P802.1Qcr/D0.5 – Last Comments

Johannes Specht (University of Duisburg-Essen)

The following comments P802.1Qcr/D0.5 are unresolved

Figure 8-12—Flow classification and metering elements

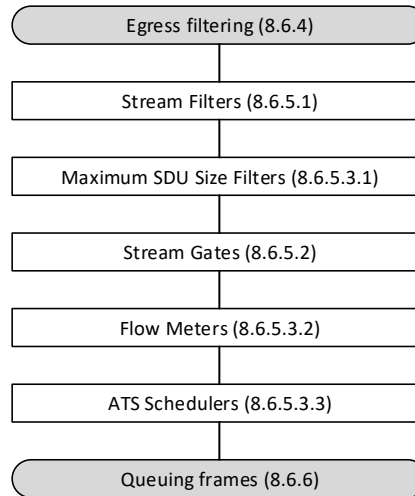
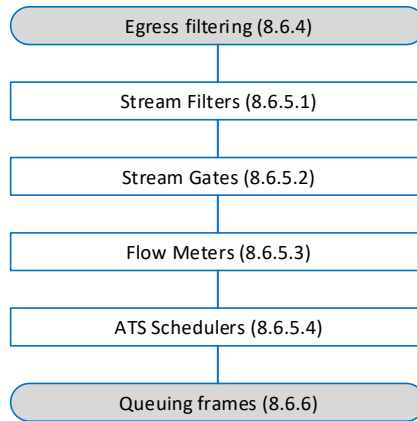
Since D0.4 stream filter specifications, which were part of stream filter in the original PSFP, have been taken out of stream filter and specified in separate subclause. In addition, Max SDU Size Filter is shown in Fig 8-12 as a separate component outside of the stream filters, as a result of the resolution of the comment #37 on D0.4. Such changes may raise new concerns about whether changing the original meaning of the PSFP. After rereading the original PSFP std, I incline to think that the MAX SDU filter has been specified in Qci as a real entity included in the stream filter specification that is present in the stream filter, while the others contained in stream filter specifications, such as for flow meter, are only identifiers (i.e. references). This can be observed in the FilterSpecification data type specified in 12.31.2.5 a), which is an interger value representing a Maximum SDU size. This proves that the stream filter specification does contains a real entity of Max SDU size filter which in this case requires only a threshold value, while stream filter specifications are specified in Qci as part of stream filter instance table. Thus, the Max SDU size filter is part of and resides in stream filter, which is already the fact in PSFP.

I would suggest the following changes. 1): moving the text under the current 8.6.5.3 stream filter specifications and 8.6.5.3.1 Maximum SDU size filters back to 8.6.5.1 stream Filters, in the same way as in Qci. The stream filter specifications, as part of stream filters, may contain a max sdu filter (real entity) and identifiers (not entity but only references) to flow meter and ATS shapers. 2) make the current 8.6.5.3.2 Flow meters to be 8.6.5.3 and 8.6.5.3.3 ATS shapers to be 8.6.5.4, so that they are specified on the same subcluase level as stream filters and stream gates. 3) in Fig 8-12, either move the block for Max SDU size filters into the stream filters, or completely remove it.

DISCUSS
See #4

- Variant 2 is derived from Variant 1:
 - Puts the set of stream filter specifications and maximum SDU size filtering functionality into Stream Filters, as was in Qci, including changes of the clauses, figures, etc.
